Service Letter No. 360

September 5, 1961

SUBJECT: Flap Retraction

MODELS AFFECTED: PA-24 and PA-24 "250" Comanches, Serials 24-1 to 24-356 inc., 24-358 to 24-1424 inc., 24-1426 to 24-2513 inc., 24-2515 to 24-2545 inc., 24-2549 to 24-2582 inc., 24-2584 to 24-2590 inc., 24-2593 to 24-2625 inc., 24-2627 to 24-2647 inc., 24-2649 to 24-2652 inc., 24-2655 to 24-2664 inc., 24-2666, 24-2668 to 24-2675 inc., 24-2677 to 24-2679 inc., 24-2681 to 24-2698 inc., 24-2700, 24-2701, 24-2702, 24-2704 to 24-2714 inc., 24-2716, 24-2718 to 24-2720 inc., 24-2722 to 24-2724 inc., 24-2726, 24-2728, 24-2730, 24-2732 to 24-2735 inc., 24-2737, 24-2738, 24-2742 to 24-2744 inc., 24-2746 to 24-2751 inc., 24-2755, 24-2758, 24-2761 to 24-2764 inc., 24-2770, 24-2773, 24-2774, 24-2776 to 24-2783 inc., 24-2787 to 24-2792, 24-2794, 24-2799, 24-2803, 24-2804, 24-2808 to 24-2810 inc., 24-2813, 24-2816, 24-2823, 24-2827, 24-2828, 24-2830, 24-2833 and 24-2834.

SERVICE LETTER NO. 360

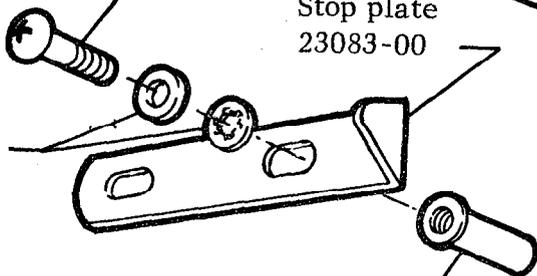
Field service reports indicate that in a few cases, under certain operating conditions, the flaps on the subject aircraft may, when retracted, extend beyond the normal, fully retracted position. This over-retraction of the flap or flaps has resulted when the flaps have been extended to aid in take-off and, later, retracted at airspeeds in excess of speeds recommended for flap operation.

Kit No. 754 413 consists of a flap stop plate for each flap, necessary hardware for its attachment and instructions for installation. This kit provides a positive stop for the flap retraction mechanism. Reference to the attached sketch may be made for details of installation. It is recommended that this kit be installed on all Comanche aircraft listed above for the serial numbers affected.

Note: Adjust the stop plate (23083-00) so that the travel plate (20674-00) is restricted to the extent that the flap will not go past the flap "up" and "locked" position.
